SERVICE INSTRUCTION

RUNNING MODIFICATIONS ON

ROTAX® ENGINE TYPE 912/914 (SERIES)

SI-912-020 R4

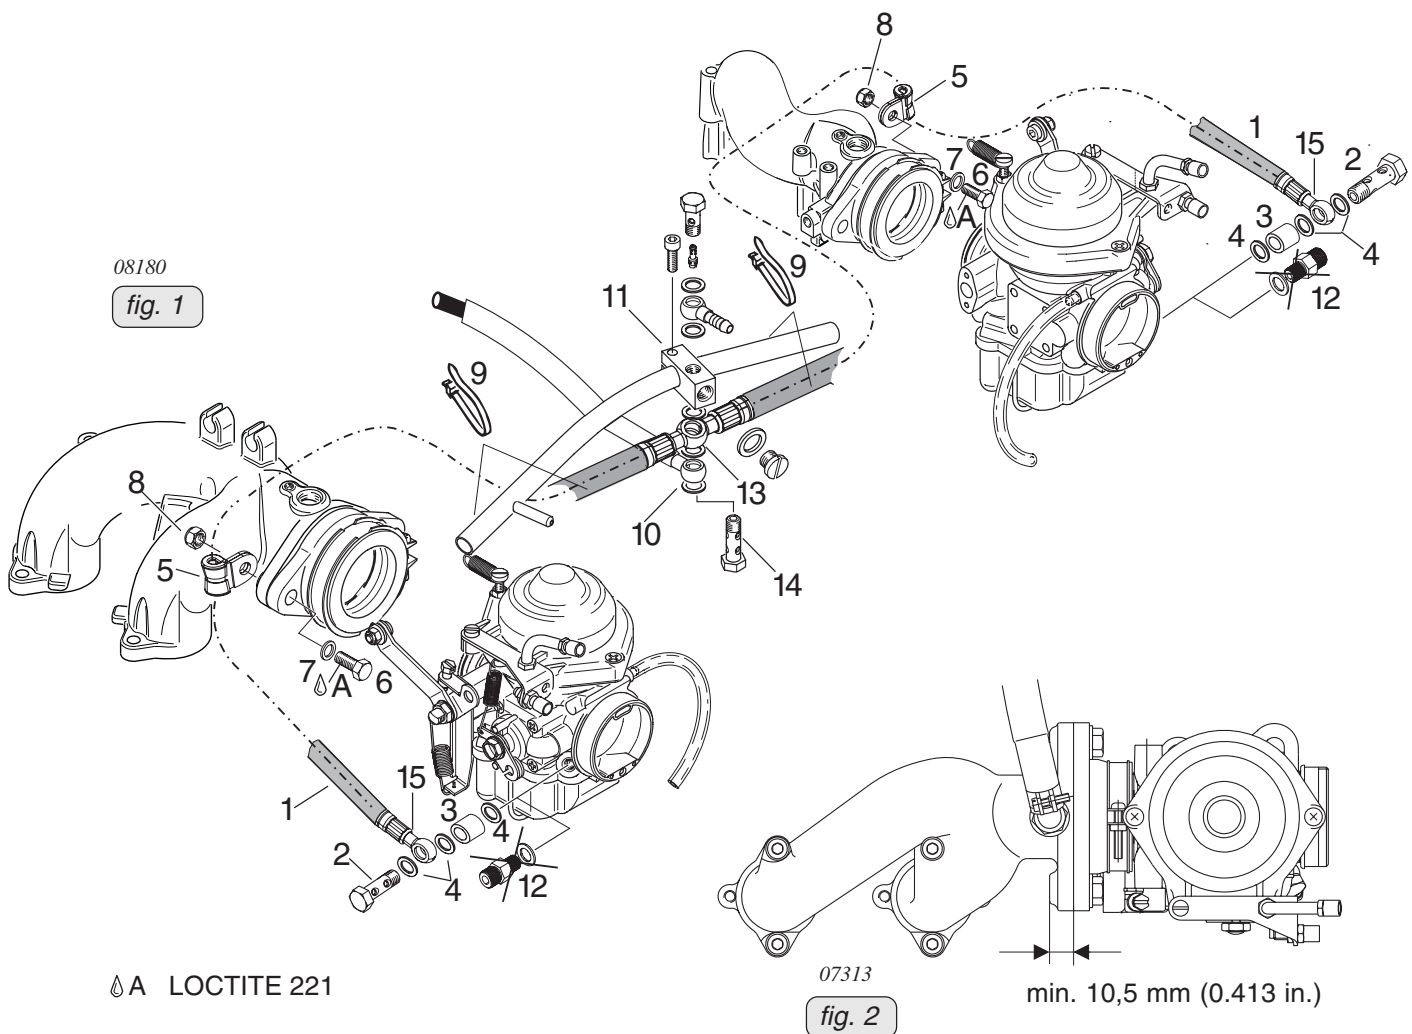
In the course of continuous development and for better assembly and maintenance a new flexible fuel line (part no. 874910) has been introduced.

Installation of this new fuel line requires the following modifications:

- mechanical machining at the intake manifold for the attachment of the cable clamp. At engine repair/general overhaul be aware that the fixation of the flexible fuel line needs an appropriate contact surface. If necessary replace the intake manifold or machine the contact surface according to the following instruction.

- Install the flexible fuel line (1) with the double ring hose nipple (13) and sealing ring (10) on the clamp block (11). Tightening torque of banjo screw (14) 10 Nm (90 in. lb.) (see fig. 1).

- Install the ring hose nipple (15) with distance sleeve (3) and sealing ring (4) on the carburetors . Tightening torque of banjo screw (2) 10 Nm (90 in. lb.)

- For installation on an old style intake manifold perform the following: Remove the intake manifold and machine the nut/clamp contact area until the surface is parallel with the sealing surface of the carb socket. The thickness of the material must not be dressed down less than 10,5 mm (0.413 in.) and should be smooth and flat so that the nut/clamp assembly has an even contact surface (see fig. 2).

- Ensure proper support of the flexible fuel line. Install Hex. screw (6) and washer (7) with 15 Nm (133 in. lb.). Install the cable clamp (5) at the hex. screw (6) of the carburetor socket with the hex. nut (8). Tightening torque of hex. nut (8) 24 Nm (213 in. lb.)

- **CAUTION:** While tightening hex. nut (8), hold hex. screw (6) with a wrench to prevent it from loosening. Always fix the flexible fuel line at the compensation tube with clamps (9) in such a way that no wear is possible.

fig. 1

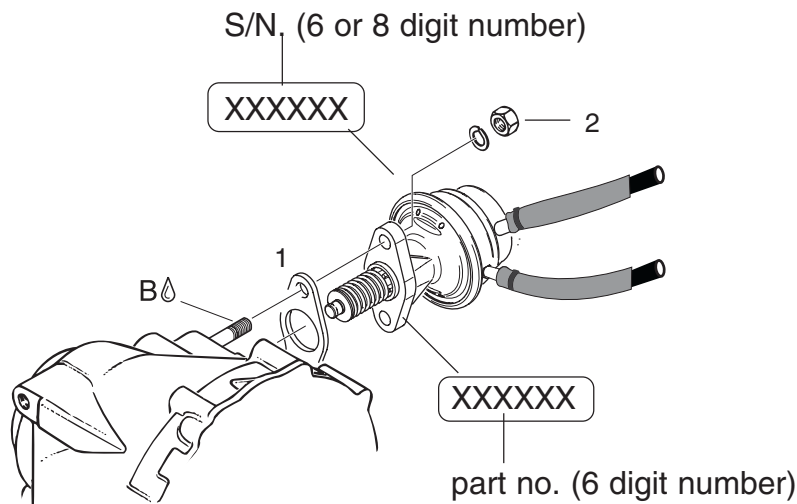
In the course of continuous development a new gasket (1) (part no. 950226) has been introduced.

The gasket is interchangeable.

- ◆ NOTE: On the sealing surfaces of the gearbox housing and the fuel pump no sealing compound has to be used.

fig. 1

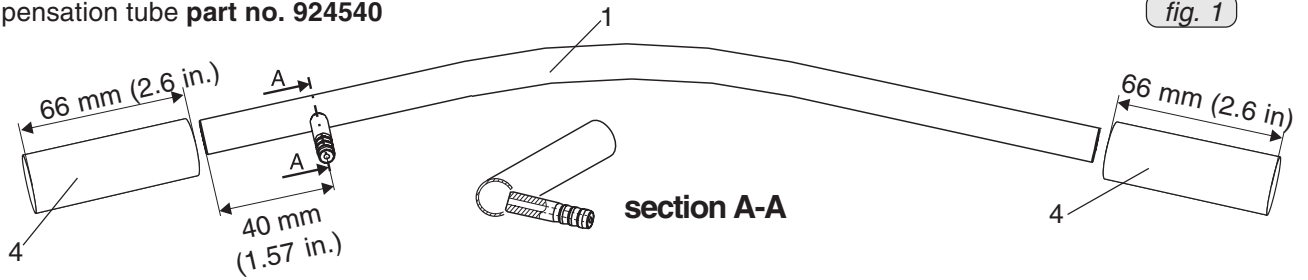
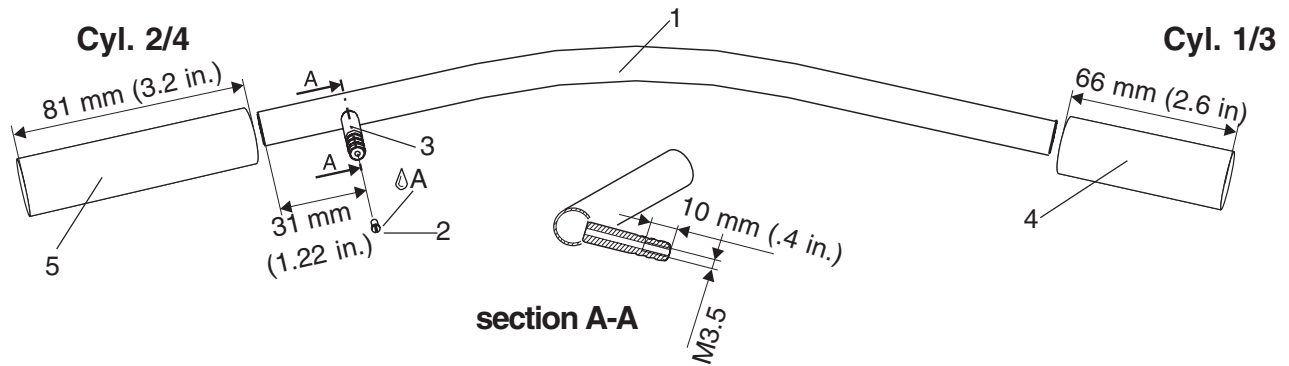
In the course of continuous development a new compensation tube (1) (part no. 924541) has been introduced which the synchronization to make it easier, the tube must not removed.

- position of connection fitting (3) on compensation tube remains approximate constant
- additional screw (2) part no. 940980 for connection fitting (3)
- new tube (4) part no. 956143 (5) part no. 956141

- ◆ **NOTE:** In case of interchangeable it is not possible to exchange individual parts. The new compensation tube are only **together** interchangeable with the tube part no. 956141. In case of spare parts the relevant configurations must be observed.

fig. 2

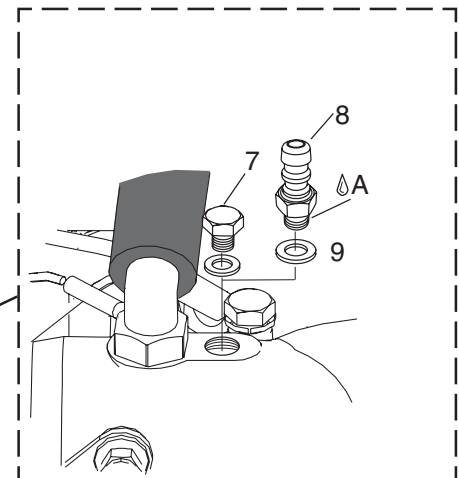
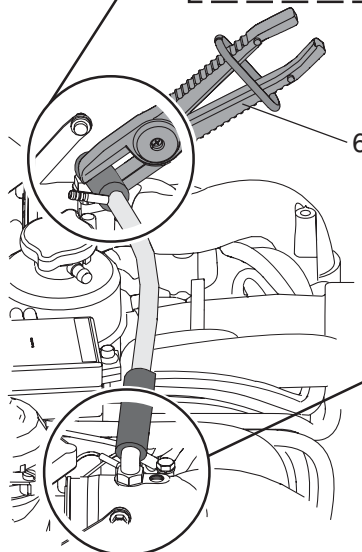
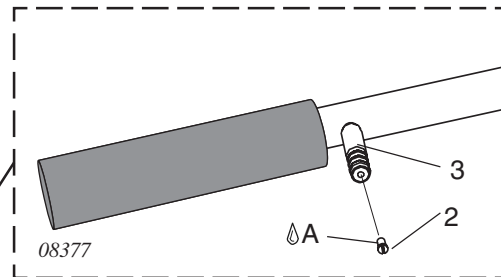
1. Install the vacuum gauge.
2. Clamp the tube with hose clamping pliers (6). Observe the position! The tube (1) must not removed.
3. Unscrew the screw (7).
4. Install the hose nipple M6 (8) with the sealing ring (9).
5. After synchronization tightened the screw M6x6 (7) with LOCTITE 221.

1. Unscrew the screw (2) from the connecting fitting (3) for indicating instrument.

- ◆ **NOTE:** If it is not possible to stabilize the intake manifold pressure, tighten the screw M3.5x6 (2) with LOCTITE 221. Install color markings on the screw.

fig. 2

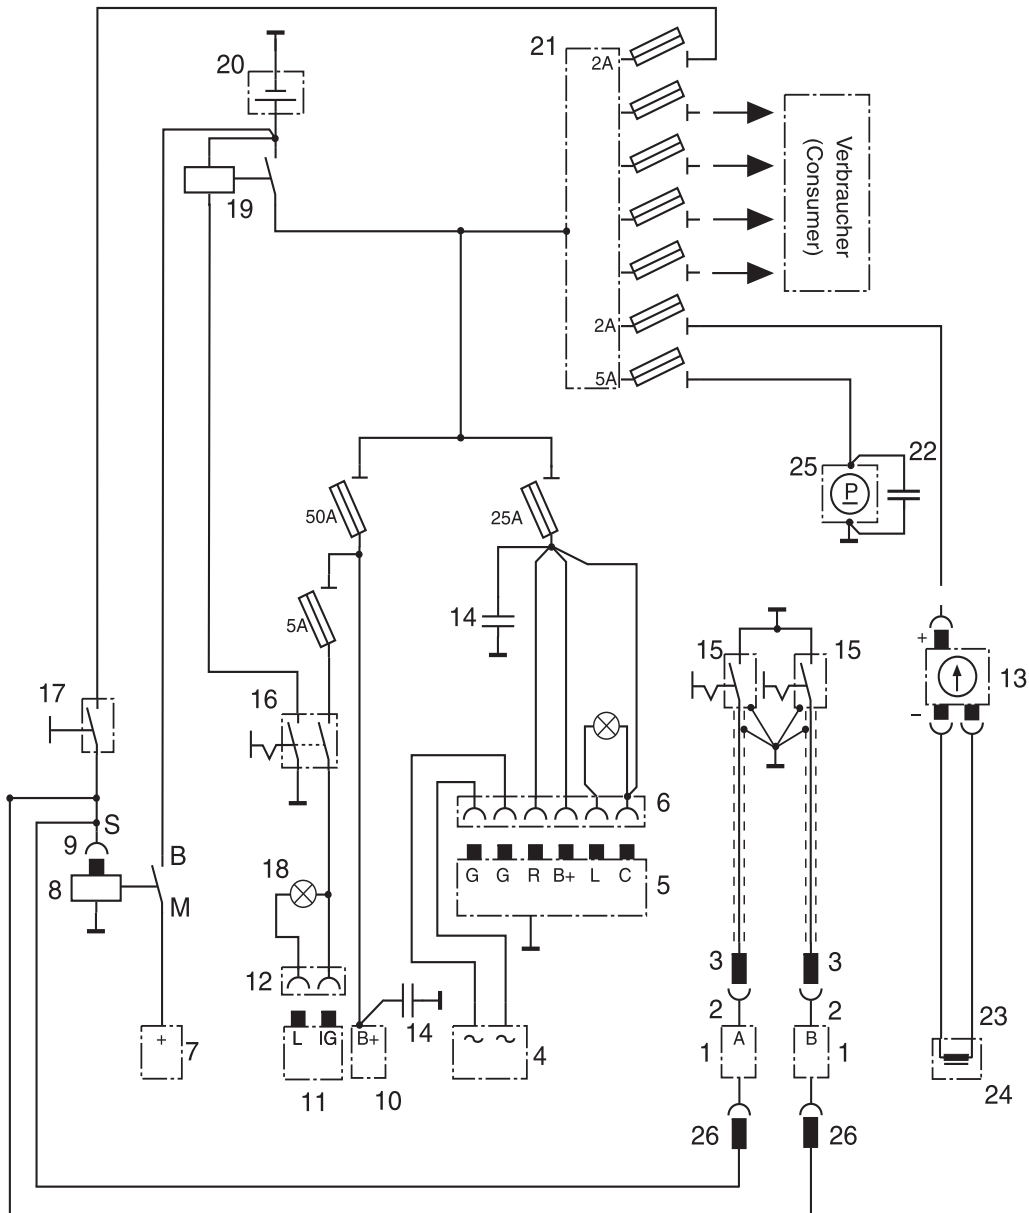
In the course of further development and standardization an electronic module for delayed start up ignition timing has been introduced. This module can be activated by a 12 V signal. Without this optional 12V activation the function works the same way as on the well-proven previous module.

- 1 wire of each module circuit A and circuit B (6-pole) to start relay control signal wire (see position 26 in fig. 1) must be supplied by the aircraft manufacturer. Therefore the rubber plug of the pin terminal must be removed before!
- Time factor for delaying ignition timing at start until switching to advanced ignition: After starting the engine and as soon as the starter/relay is not powered anymore, the engine continues to further run for 3-8 seconds with delayed ignition.
- Do not connect the signal wire to the electric starter motor - as the circuit has not voltage protection.
- Do not power the advanced start terminal permanently with 12V. The delay timer function would be bypassed and charging speed might vary (depending on internal tolerances, trigger gap etc.).

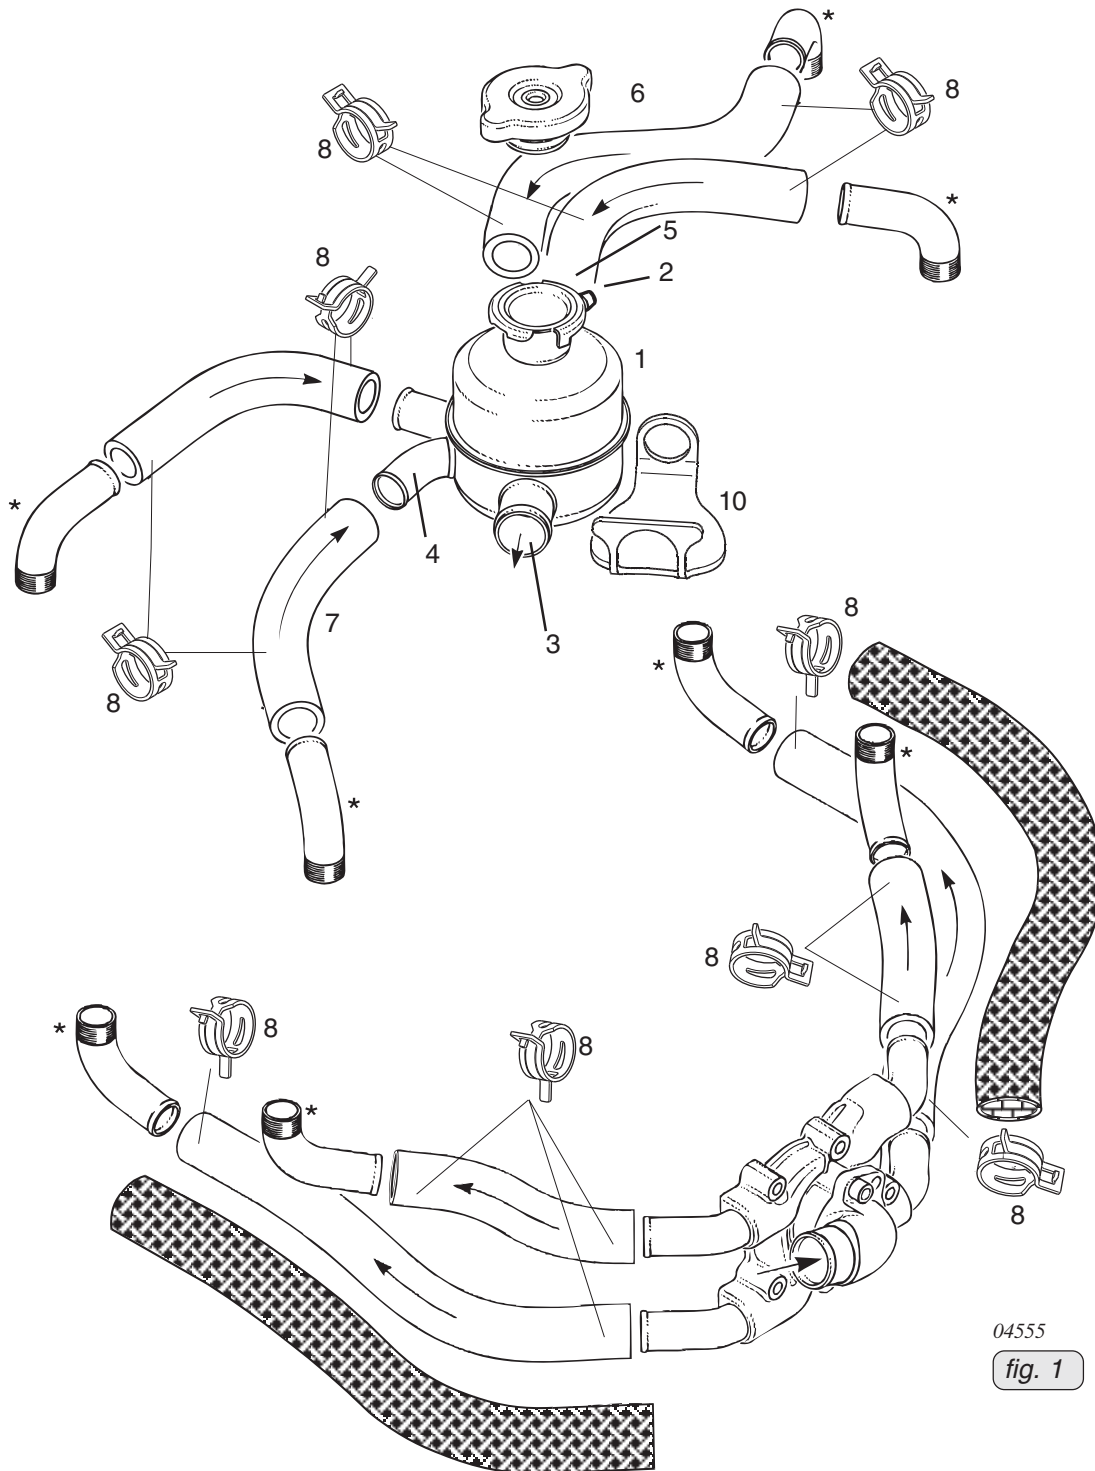
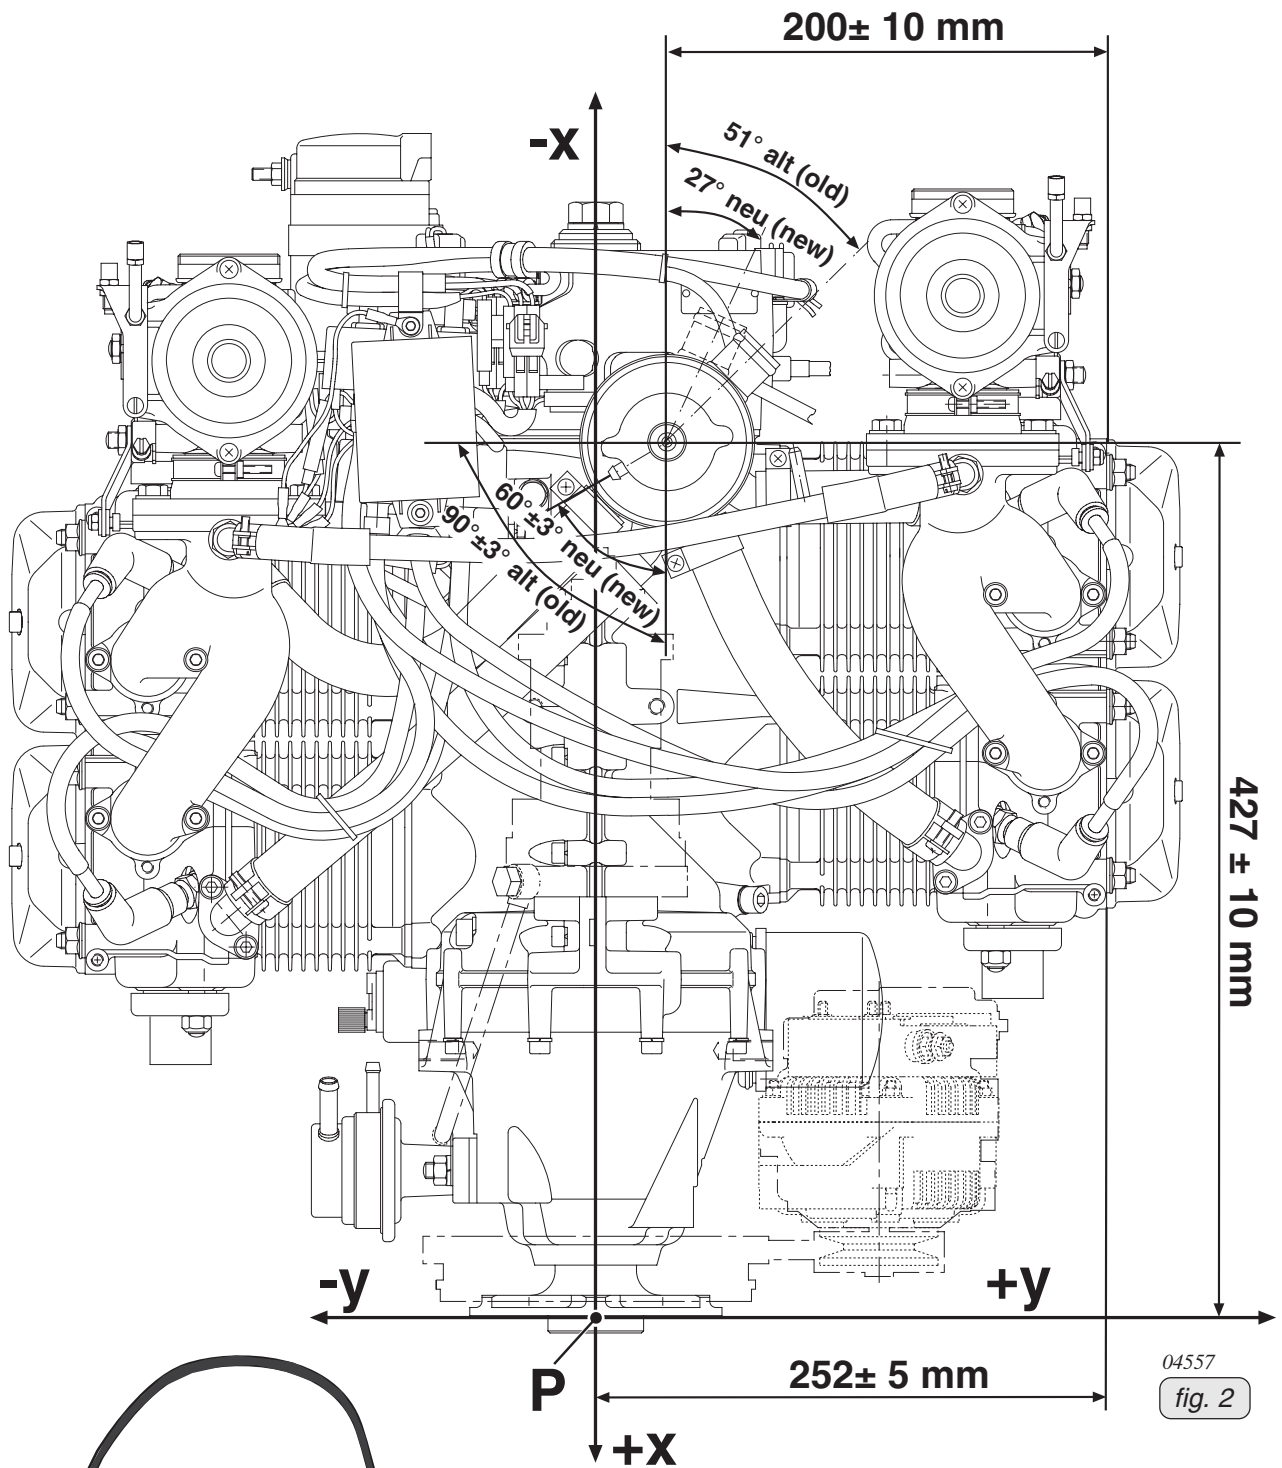
In the course of further development and standardization the position of the expansion tank (1) has been optimized!

- position of connection (2) to overflow bottle (from 0° to 30±3°)
- position of connection (3) to radiator (from 51° to 27±3°)
- angle of inlet socket (4) from cylinder 4 (34° inclined)
- length of inlet socket (5) from cylinder 3 (length increased by 13,4±3 mm)
- length of coolant hose (6) from cylinder 1 (length increased from 270 mm to 285 mm)
- length of coolant hose (7) from cylinder 4 (shortened from 100 mm to 85 mm)
- new spring type hose clamps (8) to attach the coolant hoses (expansion tank and water pump)

- Install the coolant hose (6) 285 mm to cylinder 1 and the new coolant hose (7) 85 mm to cylinder 4. For attaching all the coolant hoses from expansion tank, water pump, cylinders, use the new spring type clamps.

■ **CAUTION:** Take care of appropriate slip-on length of the coolant hoses on the corresponding connection socket. Verify tight fit of clamps and hoses and check for leakage. Always fit the clamps such that they can not wear on any component and use a suitable tool (see fig. 3) for fitting them.

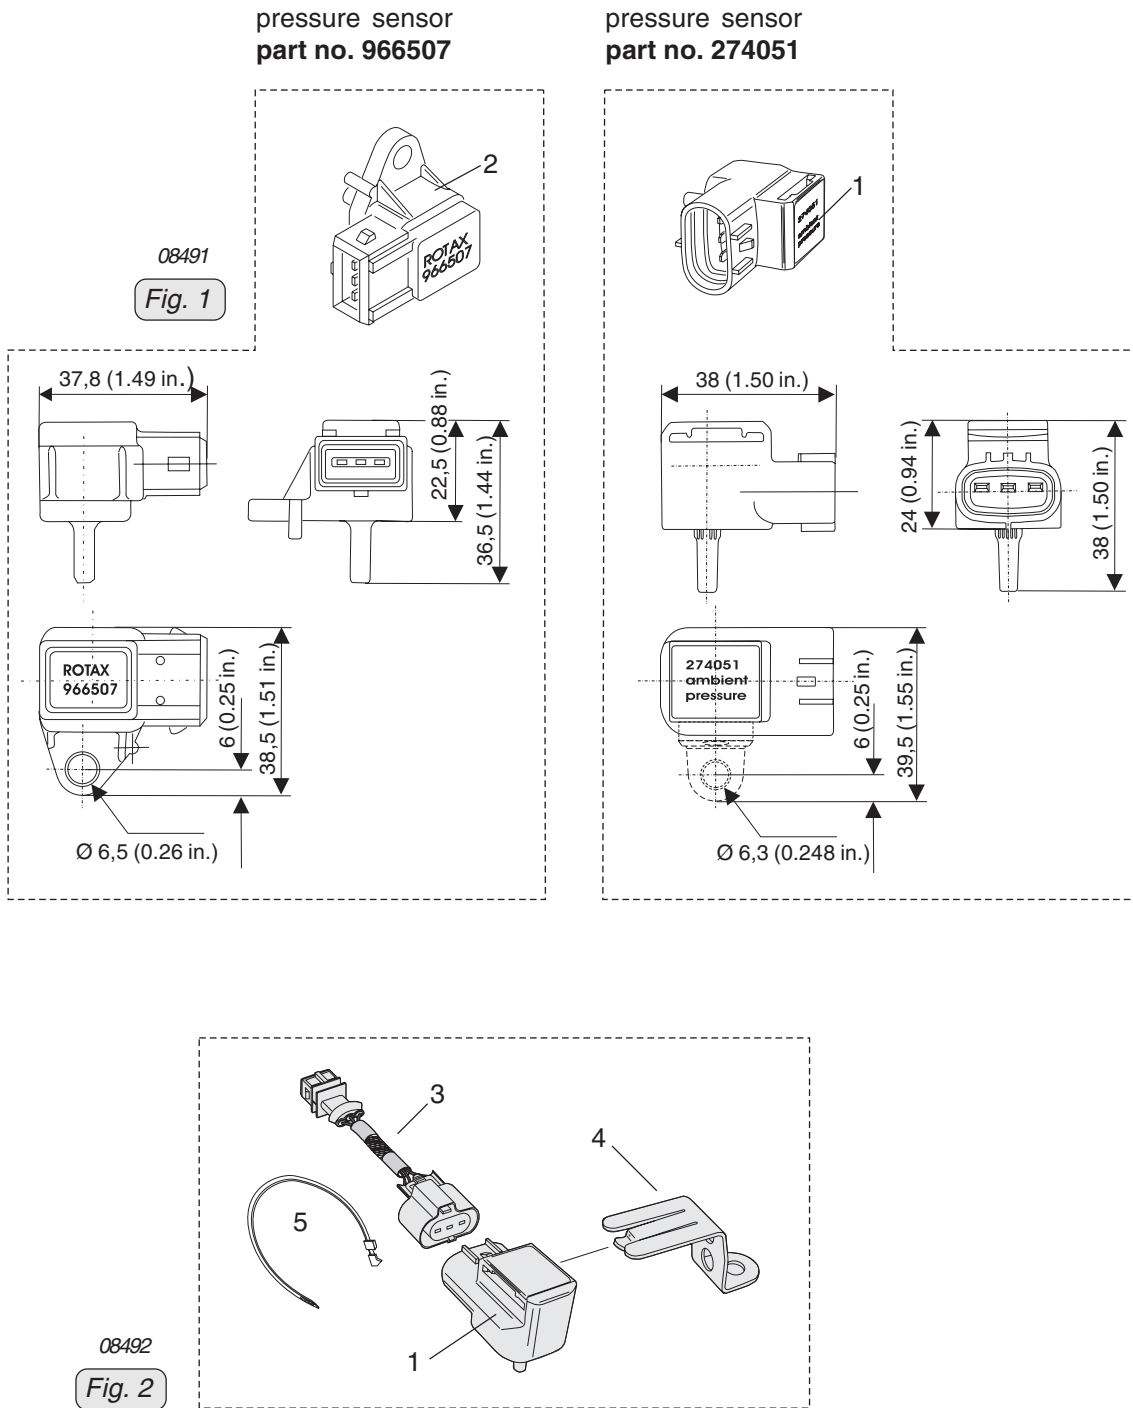
Due to the termination of production of the ambient pressure sensor (part no. 966507) a new ambient pressure sensor part no. 274051 has been introduced. The new ambient pressure sensor is of different size and also has a different connector. The connection for the wiring harness had to be changed.

1. Disconnect the pressure sensor (2) from the wiring harness.
2. Connect adapter cable (3) to wiring harness and to the new pressure sensor (1).
3. Install bracket (4) onto pressure sensor.

■ CAUTION: Route all wiring as such that there will be no sharp bends or chafing.
4. Position adapter cable and secure with cable binders (5).
